**Re: Initial Submission Review:** 60th Avenue at Box Elder - Infrastructure Site Plan  
**Application Number:** DA-1478-14  
**Case Numbers:** 2024-6039-00

## *Initial Submission Review*

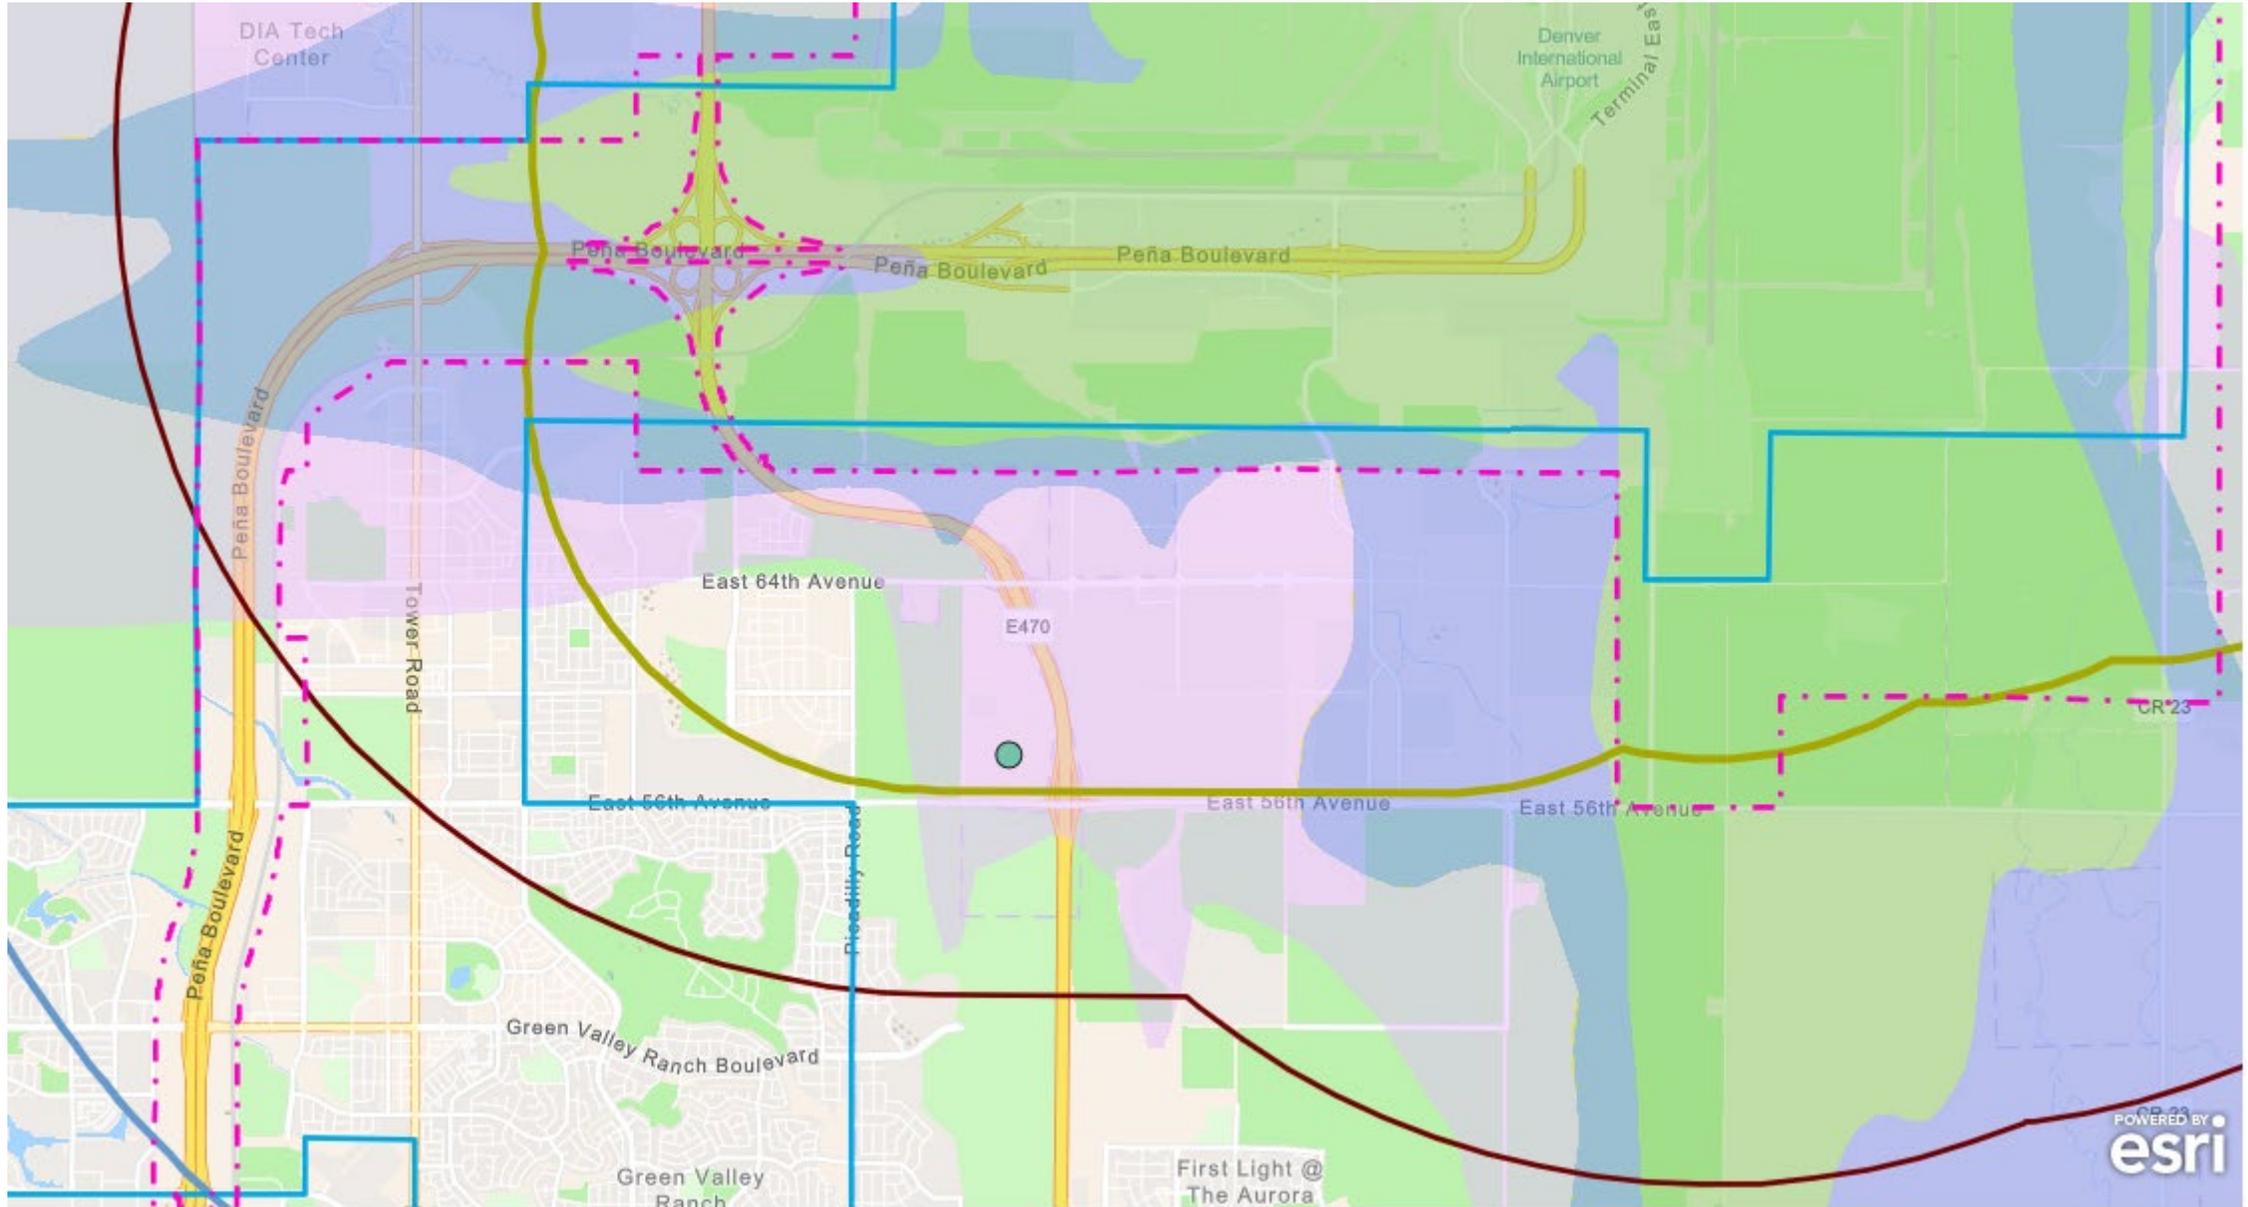
Public Service Company of Colorado's (PSCo) Right of Way & Permits Referral Desk has determined **there is a potential conflict** with the above captioned project. Public Service Company has existing electric transmission lines and associated land rights along the north side of the subject property. Any activity including grading, proposed landscaping, erosion control or similar activities involving our existing right-of-way will require Public Service Company approval. Encroachments across Public Service Company's easements must be reviewed for safety standards, operational and maintenance clearances, liability issues, and acknowledged with a Public Service Company License Agreement to be executed with the property owner. PSCo is requesting that, prior to any final approval of the infrastructure site plan, it is the responsibility of the property owner/developer/contractor to have this project assigned to a Land Rights Agent for development plan review and execution of a License Agreement (via either website [www.xcelenergy.com/rightofway](http://www.xcelenergy.com/rightofway) or email [coloradorightofway@xcelenergy.com](mailto:coloradorightofway@xcelenergy.com)).

PSCo also has existing underground electric distribution facilities along the north and east sides of the subject property. As a safety precaution, PSCo would like to remind the developer to contact Colorado 811 for utility locates prior to construction.

PSCo requests that 10-foot-wide utility easements are dedicated abutting all public rights-of-way and private drives.

## DEN Aviation Noise:

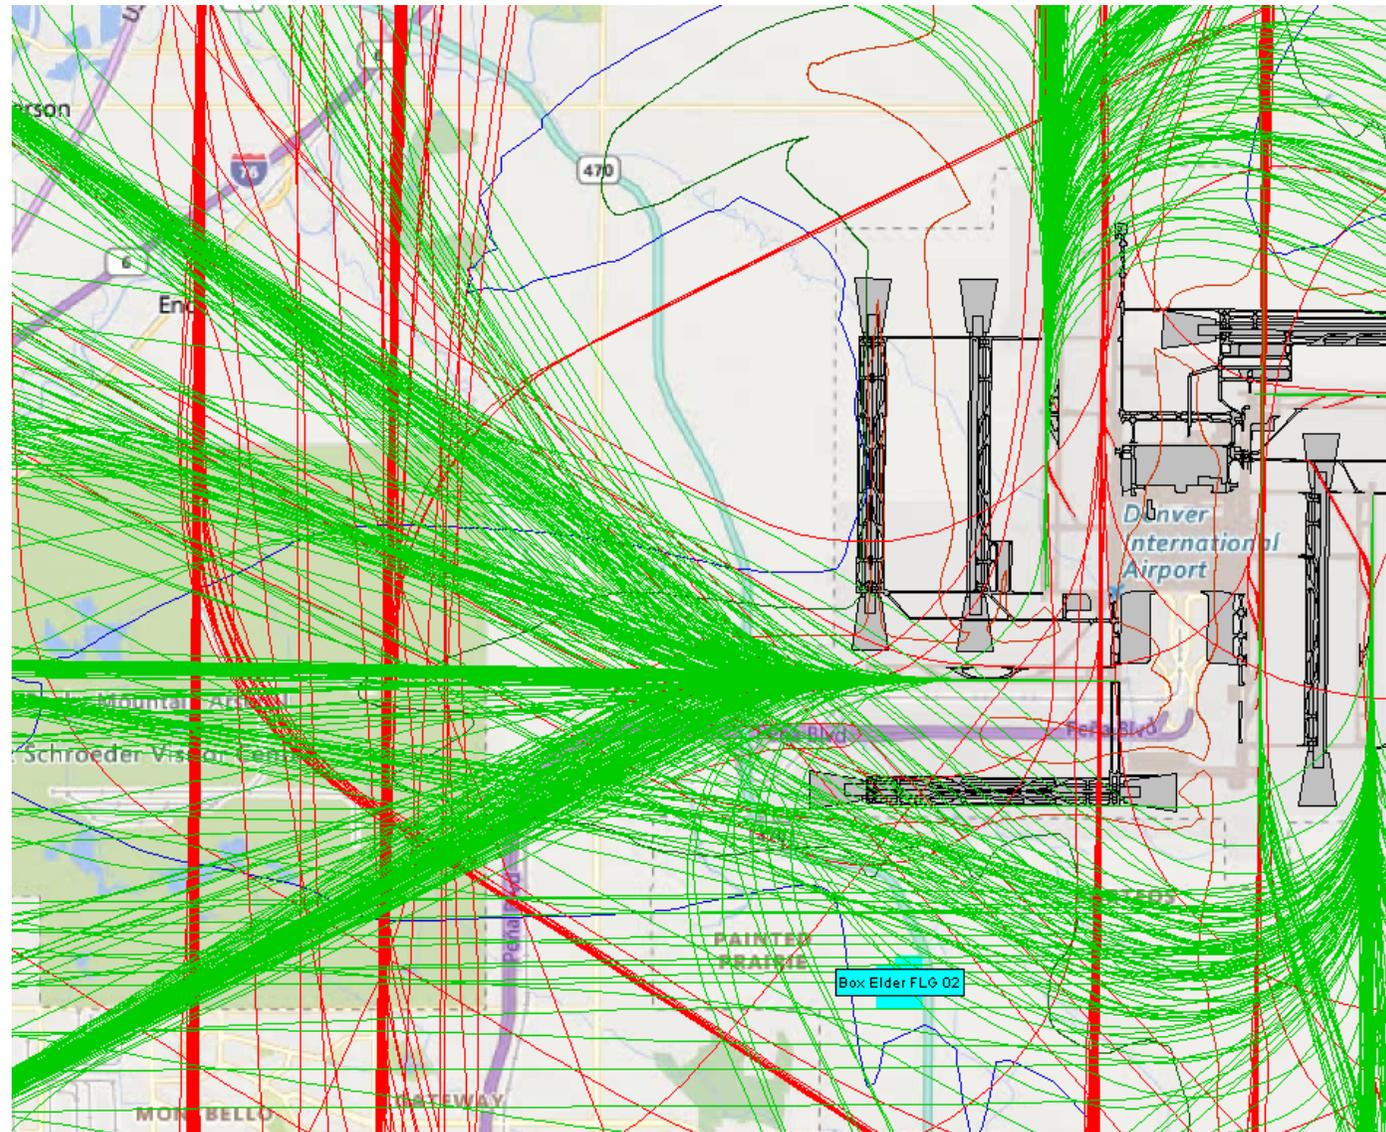
This property will be subject to overflights to and from Denver International Airport (DEN). Included are flight track maps showing the different flight track pattern scenarios and their altitudes related to the arrivals and departures at DEN. All related aviation noise statements should be included in any information sharing, documentation and contracts.

This subject property area is not currently directly under an arrival pattern, the future north/south runways on the west side of the airfield will put arrivals over the subject property. The development could potentially have arrival overflights from the south at altitudes of between 1,100 feet above ground level (AGL) and 1,500 feet AGL depending on the aircraft type and what arrival runway the Federal Aviation Administration (FAA) air traffic controllers have directed the aircraft to land on. If the winds are out of the north aircraft will land coming in from the south on final approach to DEN. Aircraft currently arrive to DEN on runways 34L and 34R and with the potential of 4 North/South runways on the West side of the airfield there could be even more daily arrival overflights of this development. The future runways are depicted in **black and gray** on this map of flight data from 5/4/23. This days of flights depicts a typical flight pattern for a 24 period. See next page for a zoomed in version.
